**RE: West Bay Yards Mixed-Use Development
Project No. 21-2854
Partial Response to November 8, 2023 Third Round Review Comments
Shoreline Restoration Design Compliance**

Re: Narrative Response to City of Olympia Comments – 3rd Round Review Comments
(11/8/2023)

RE: West Bay Yards Mixed-Use Development
Project No. 21-2854

Attachments: **Tab A** – Concept Site Plans

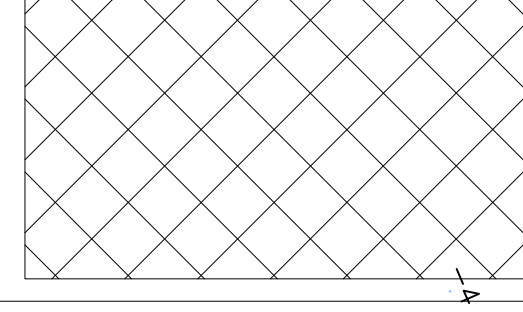
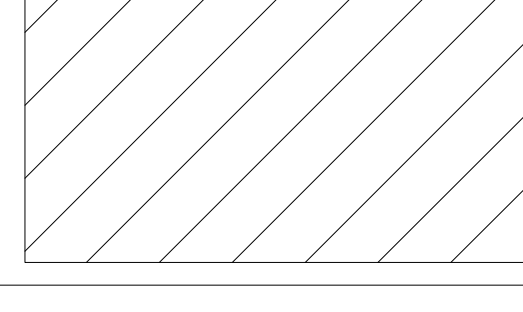
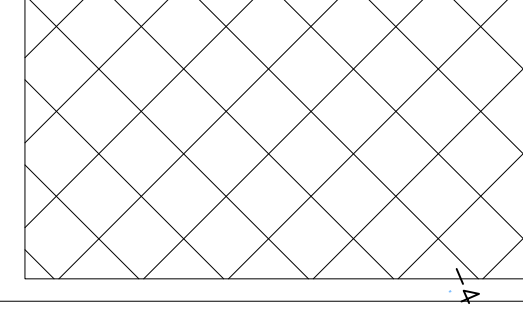
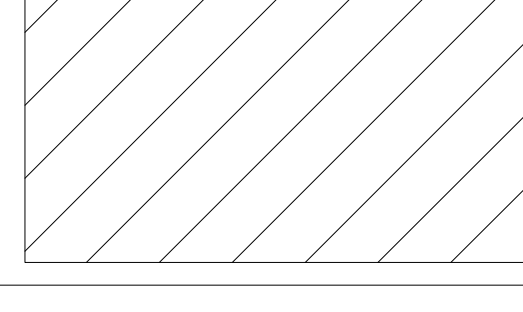
Second, the Applicant's proposed restoration is voluntary, as opposed to being required as mitigation under OMC 18.20.410 for the upland mixed-use development. As shown on the concept site plans attached at **Tab A**, Alternative 3 would push the top of the bank twelve feet back into the existing uplands, resulting in the corresponding loss of approximately 14,653 SF of private property. If the upland development triggered mitigation under the City's SMP, and the restoration project were proposed as a mitigation measure, then the City would have broad authority under OMC 18.20.240 to mandate the scope and extent of required mitigation, potentially including cutback into the upland. Here, however, the Applicant's proposed restoration project is entirely voluntary.

The Applicant's consultant team began its analysis by creating concept site plans for Alternatives 2 and 3, attached at **Tab A**, as described in the Design Report. These site plans were then used to identify and calculate the total available riparian vegetation area and associated planting for each alternative. The corresponding calculations are attached at **Tab B**. The calculations demonstrate that Alternative 3, while it would have less fill waterward of the OHWM, would also result in a loss of 13,834 SF of riparian planting area along the approximately 1,100 linear-foot shoreline on the Property, or a total reduction of approximately 13.6% of restored riparian vegetation and planting as compared to Alternative 2, the Original Design. The Project's biologist, Grette Associates, reviewed the concept site plans for Alternatives 2 and 3 and concluded that the loss of the riparian planting area in Alternative 3 would degrade several important functions and result in diminished riparian function and reduced restoration value when compared to the Original Design. In addition, because of the loss of riparian functional value, the analysis concludes that Alternative 3 would “compromise the intended goal of the shoreline restoration project” in the 2016 Report. The analysis provides objective quantification of the loss of restoration value, which would result from Alternative 3 using the current NOAA Fisheries *Puget Sound*

SQ/FT of Vegetation Lost from Alt 2 to Alt 3 7541

% Riparian vegetation Lost from Alt 2 to Alt 3 28.0

SQ/FT of Vegetation Lost from Alt 2 to Alt 3 6293

% Riparian vegetation Lost from Alt 2 to Alt 3 8.4

SQ/FT of Vegetation Lost from Alt 2 to Alt 3 13834

% Riparian vegetation Lost from Alt 2 to Alt 3 13.6

Figure 5-1 Proposed conceptual design cross section for WBY creating backshore/berm and foreshore.

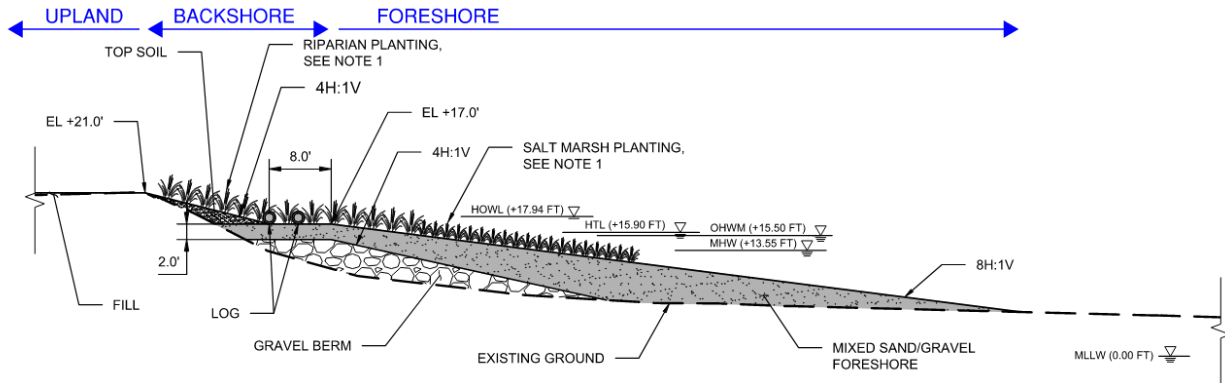
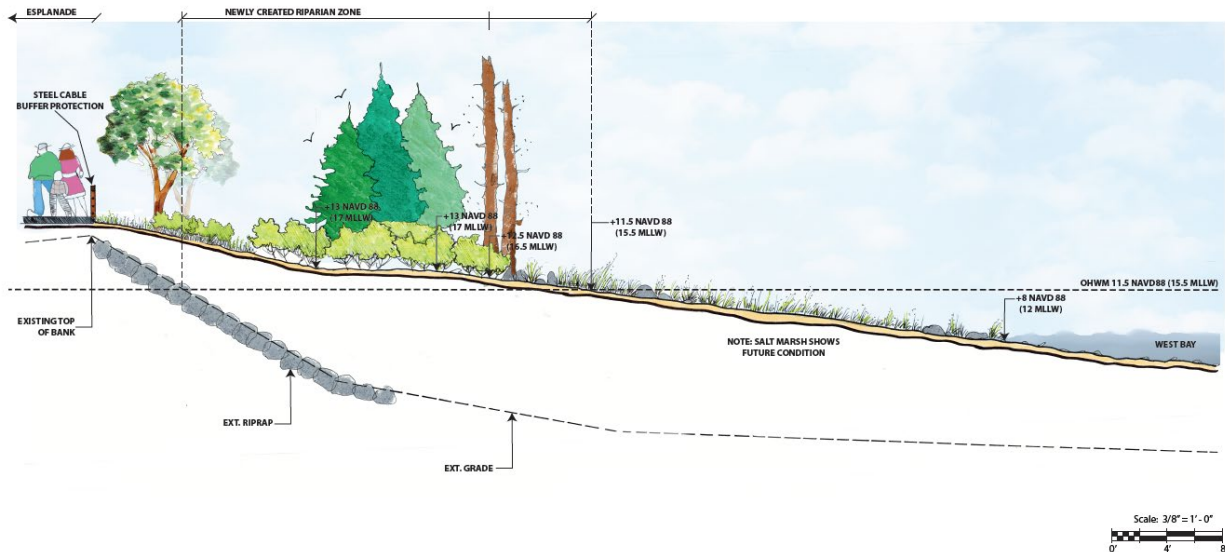
Address efforts to avoid creation of upland areas following provision in OMC 18.20.855(i), specifically the underlined section:

"1. Restoration and enhancement projects shall not extend water-ward more than the minimum necessary to achieve the intended result and shall not result in the creation of additional upland area."

The proposed restoration design for WBY includes placement of fill to restore the existing ecologically degraded shoreline and to enhance public access to the shoreline. The proposed restoration does not create new/additional upland areas. However, the proposed restoration includes creation of backshore/berm and foreshore, see Figure 5-1 and Figure 5-2. The proposed design, at the preliminary level, creates an average backshore width of approximately 33 to 36.

The proposed shoreline restoration design by WBY in our opinion does not create new or additional upland areas and does conform to the provisions of the City’s SMP Section 2.32.F. because:
